Inter-Office Memorandum

Date: December 2, 2011

Subject: Revised Urban Street Typical Section
Figures 14-2H and 14-2F in 2001 Roadway Design Manual

TYPICAL URBAN DRIVEWAYS
FIGURE 14-2F
(REVISED)

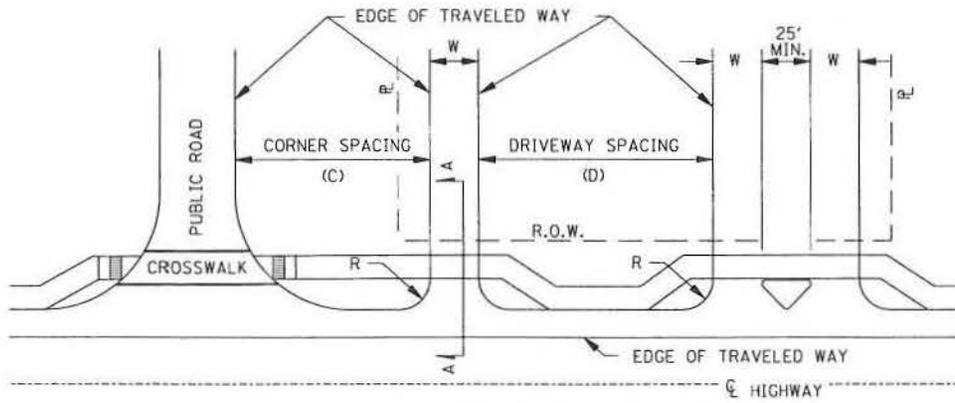
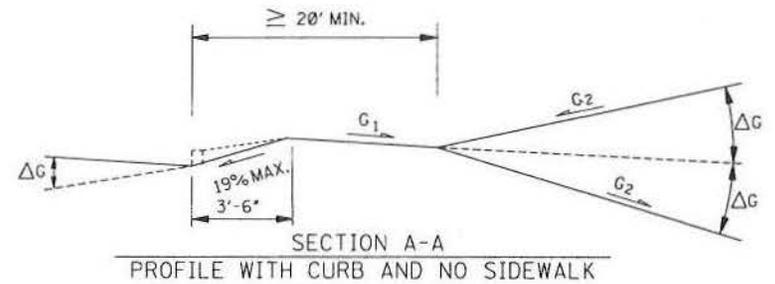
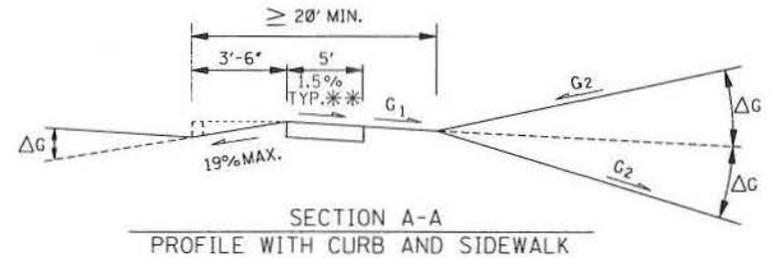
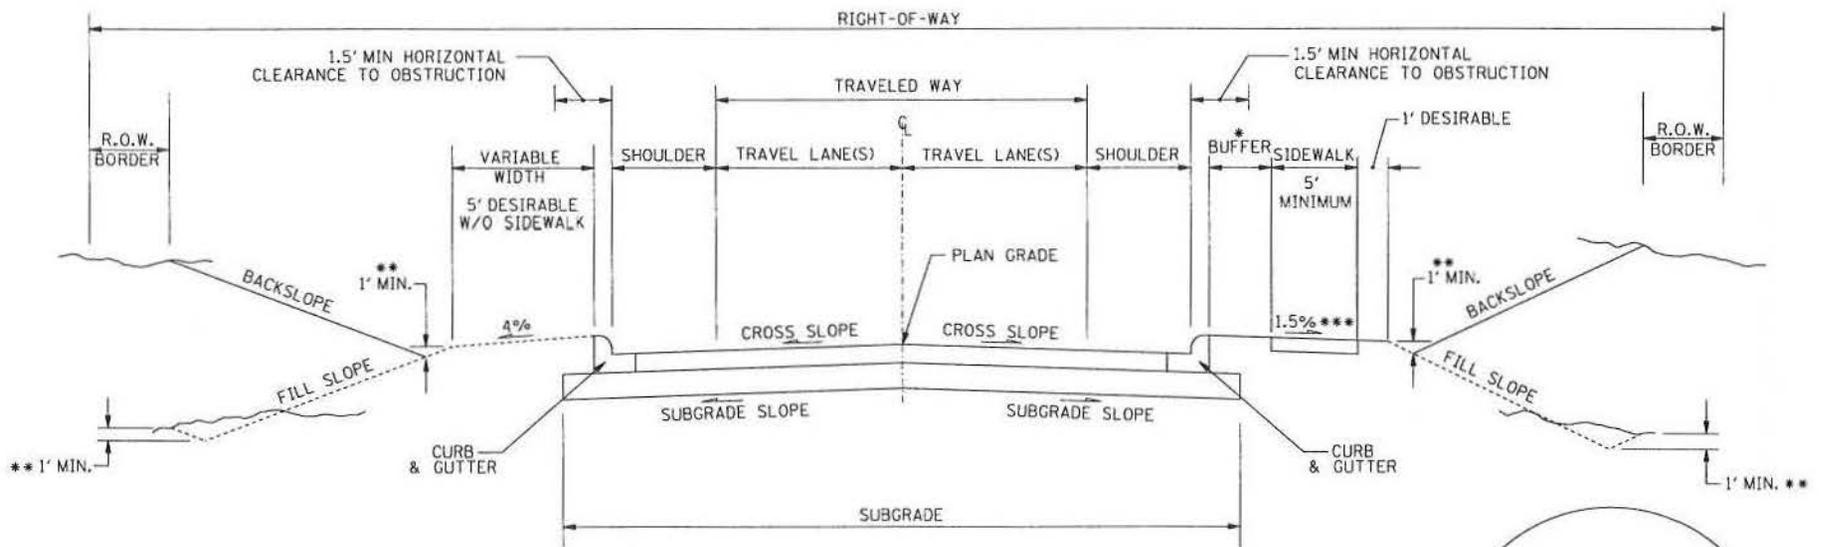
A revised Figure 14-2F is also attached. This revision incorporates the changes described above to the profile sections, and also revised plan views for different sidewalk configurations.

TYPICAL SECTION NOMENCLATURE
(URBAN STREETS WITH CURBS)
FIGURE 14-2H
(REVISED)

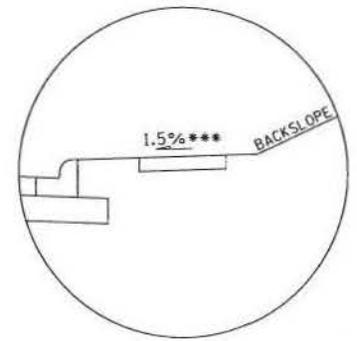
1. The 2% slope across the sidewalk is reduced to 1.5% desirable, with 2% being the maximum allowable slope. A 1.5% cross slope will adequately drain the surface and provide some construction tolerance.
2. The fill section on the right side of the current figure shows a 2% slope across the sidewalk sloping towards the roadway. The revised figure shows the sidewalk sloping in the opposite direction, away from the roadway. The purpose of this is to reduce the amount of drainage entering into the stormdrain system. A fill ditch is also shown to carry side drainage to the next cross-drain.

3. The cut section shown on the right side of the current figure also shows the area behind the curb sloping towards the roadway. While this method is acceptable, it is more desirable to have this area sloping away from the roadway also, which would require that a ditch be incorporated behind the curb & gutter and sidewalk as shown in the revised figure. However, this may not always be practical in urban sections due to Right-of-Way constraints, and should be evaluated on a case-by-case basis. See Detail A in the revised figure.

4. In cases where it is not practical to design according to item number three above, and where alternating fill and cut sections would result in alternating directions of the slope of the area behind the curb, it is acceptable to slope this area towards the roadway as shown in Detail A of the revised figure, even in the fill sections. However, the stormdrain system for the roadway shall be designed so that this additional drainage can be accommodated (additional inlets, larger stormdrain pipes, etc).

5. The fill section on the left side of the current figure is shown correctly. However, without the sidewalk the slope should be 4%. Once again, an attempt should be made to slope the area behind the curb away from the roadway in both cut and fill sections, and incorporate a ditch behind the curb & gutter as described in item number three above, and as shown in the revised figure.

6. The ditches shown in the revised figure are minimum, and shall be adjusted as necessary to provide adequate drainage.
7. The left side of the current figure shows a desirable width of five (5) feet for the area behind the curb. A three (3)-foot width is acceptable here.

8. The right side of the current figure shows a three (3)-foot desirable buffer width between back of curb and sidewalk. The desirable buffer width should equal the driveway radii. It should be noted the Design Manual states that the minimum turning radius is three (3) feet for residential driveways, and five (5) feet for commercial/industrial driveways, measured from the back of the curb. Preferably, these minimum radii should be increased to five (5) feet and ten (10) feet respectively,
